Certificate of Appropriateness

1114-1116 W. HISTORIC MITCHELL ST. Mitchell Street Historic District

PTS ID 111979 COA Rebuild Facade

Current condition of façade 2016.

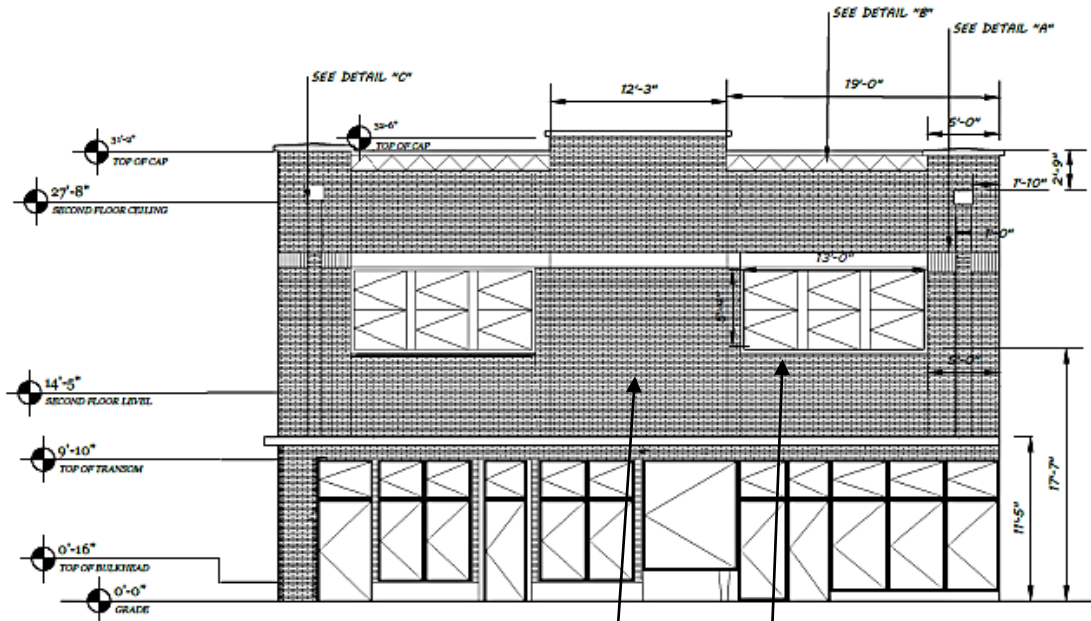
Separation of the facade is evident at left. The separation is pushing out masonry at front.

7 SOUTH FACADE
AS 1/4" = 1'-0"

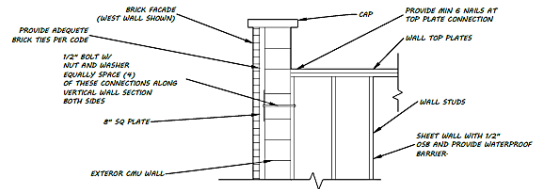
Proposed façade. Note: there will be four windows on second story and not three. Center vertical channel will be added to match current façade.
